Officer Report to Committee

Application ref:	23/0848
Ward:	Bloomfield
Application type:	Full major application
Location:	SITE BOUNDED BY THE PROMENADE, ST CHADS ROAD, WOODFIELD ROAD AND BOLTON STREET BLACKPOOL, FY1 6BN
Proposal:	Erection of a part 5, part 6 storey hotel with 143 bedrooms and ancillary facilities, with car parking to rear accessed from Woodfield Road and landscaped external seating area to front.
Recommendation:	Grant permission subject to conditions
Recommendation Summary:	The application seeks to redevelop a prominent, vacant site on Blackpool Promenade to provide modern visitor accommodation. The proposed hotel would be well designed and would help to regenerate this area of the Promenade and the wider resort as a tourism destination, and this weighs significantly in favour of the scheme. The scale of the building would have no greater impact on residential and visitor amenities of surrounding properties that St Chads Terrace which previously occupied the site. On site car parking would be limited but managed and the site is in a highly accessible location. No other issues that weigh notably in the planning balance have been identified. It is considered that the

Figure 1: Woodfield Road

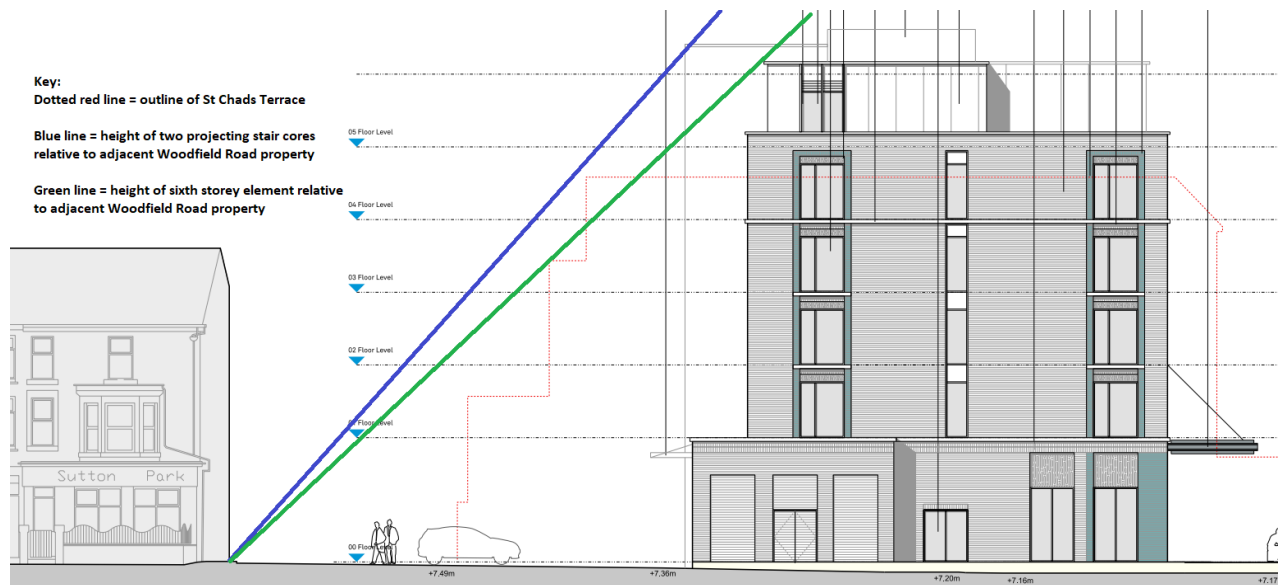
- 7.4.4 Objections have been received siting loss of outlook, light and sunlight. The locality has a densely built up urban character. Prior to its demolition, St Chads Terrace at four storeys tall (around 15.6m maximum height), was around 11 metres from the nearest properties to the east on Bolton Street, Woodfield Road and St Chads Road. The bulk of the hotel proposed would be around 21m away from those same properties and around 20.3m tall. So the hotel would be around 5m taller and the bulk would be around 10m further away.

7.4.5 The rear of the former St Chads terrace was a mix of red brick and dark render. The proposed hotel would have a lighter, well designed and coherent rear elevation which would help reflect light back towards properties to the east and would provide better outlook from windows on Bolton Street and would reduce overlooking. The proposed hotel would not have a material impact on light as the sun sets to the west, over and above impacts from the previous development on the site, given the orientation of the site in relation to the surrounding streets as demonstrated by the sketches in figures 1 and 2 below.
